AEROPRAKT INFORMATION BULLETIN

INSPECTION OF CARDAN RINGS AND AMMENDMENT TO AIRCRAFT FLIGHT MANUALS OF A-22 AND A-22L AIRPLANES.

IB A-22-13

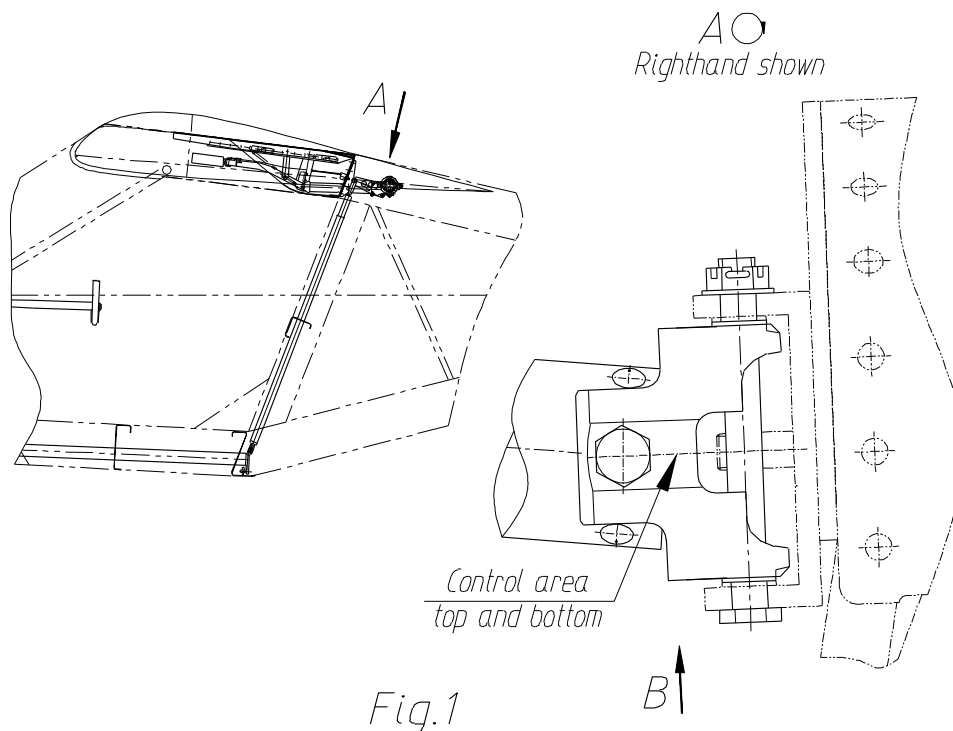
1. Inspect the cardan rings of the right and left flaperon for cracks (see fig. 1). Replace the cardan ring if any crack is detected.
2. If “S” dimension exceeds 55.0 mm check the nut tightening using torque wrench. If there is a gap between the flaperon shaft and cardan ring then the flaperon shaft deformation must be removed.
3. If “S” dimension is less than 55.0 mm then the flaperon shaft deformation must be removed and the cardan ring must be replaced.

◆ **NOTE:** Inspection and measurement of the cardan rings must be done on both right and left sides, although fig. 1 shows only the right side.

Fig.3

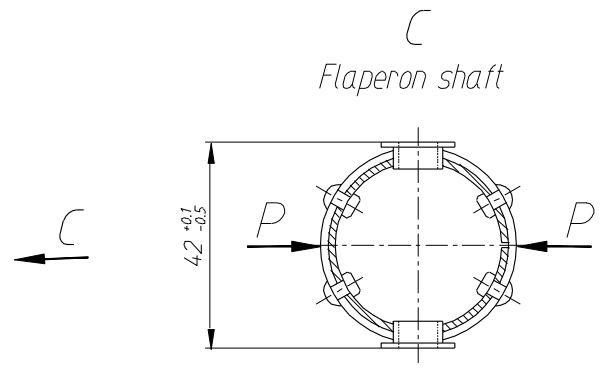
5. Removal of the deformation of the flaperon shaft must be done in vice with protecting pads. To ensure the required dimension of 42 mm between the outer faces of the bushings apply the squeezing force "P" (see fig. 3) to the shaft tube at right angle to the bushing axis.
